Access Compliance Report

Public Rights-of-Way

Intersection ID: 10032880	Main Street: NATIONS_FORD_RD	Cross Street: N/A	Location: SE
ADA ID: E3F3195C83FC	Ramp Type: ParaDiag	Initial Pass/Fail: Fail	Overall Compliance: No
Codes/Mitigation Info/Possible Solution		Field Measurements/Component Compliance	
Severity Score: 13.75

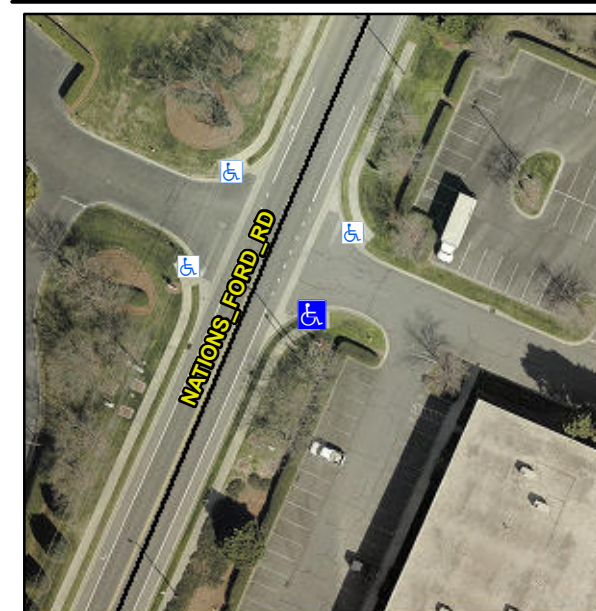
Compliance	Description	Data	Compliance	Description	Data
N/A	Ramp Length LT (in)	56.0	N/A	Ramp Length RT (in)	56.0
Yes	Ramp Width LT (in)	108.0	Yes	Ramp Width RT (in)	108.0
Yes	Ramp Slope LT (%)	3.8	No	Ramp Slope RT (%)	11.0
No	Ramp XSlope LT (%)	3.9	No	Ramp XSlope RT (%)	3.2
N/A	Landing Length (in)	N/A	N/A	DWS Provided?	N/A
N/A	Landing Width (in)	N/A	N/A	DWS Contrast?	N/A
N/A	Landing Slope (%)	N/A	N/A	DWS Length (in)	N/A
N/A	Landing X Slope (%)	N/A	N/A	DWS Full Width?	N/A
N/A	Landing Curb? (Y/N)	N/A	N/A	DWS Offset (in)	N/A
N/A	Shared Landing?	N/A			
N/A	Gutter Ponding?	N/A	N/A	Gutter Slope (%)	N/A
N/A	Gutter Lip Ht (in)	N/A	N/A	Gutter X Slope (%)	N/A
N/A	Painted X Walk1?	No	N/A	Painted X Walk2?	No
	X Walk 1 Direction	To NE		X Walk 2 Direction	To NW
N/A	X Walk 1 Width (in)	N/A	N/A	X Walk 2 Width (in)	N/A
	X Walk 1 Slope (%)	5.7		X Walk 2 Slope (%)	0.2
	X Walk 1 X Slope (%)	0.9		X Walk 2 X Slope (%)	1.2
N/A	Ramp inside XWalk1?	N/A	N/A	Ramp inside XWalk2?	N/A

Road Slope (%)	2.3	N/A	Clear Space?	N/A
	Road X Slope (%)	3.4	N/A	Clear Space to XWalk (in)	N/A
N/A	Any Obstructions?	N/A	N/A	Storm Grate/Utility Hazard?	N/A
	Obstruction Type			Storm Grate/Utility Type	
		N/A			N/A
			Yes	Surface Condition? (G/P)	Good
			N/A	Curb Slope (%)	6.7

Remove & Replace Curb Ramp With Two New Directional Ramps or Equivalent.

R304.5.3, R304.3.2
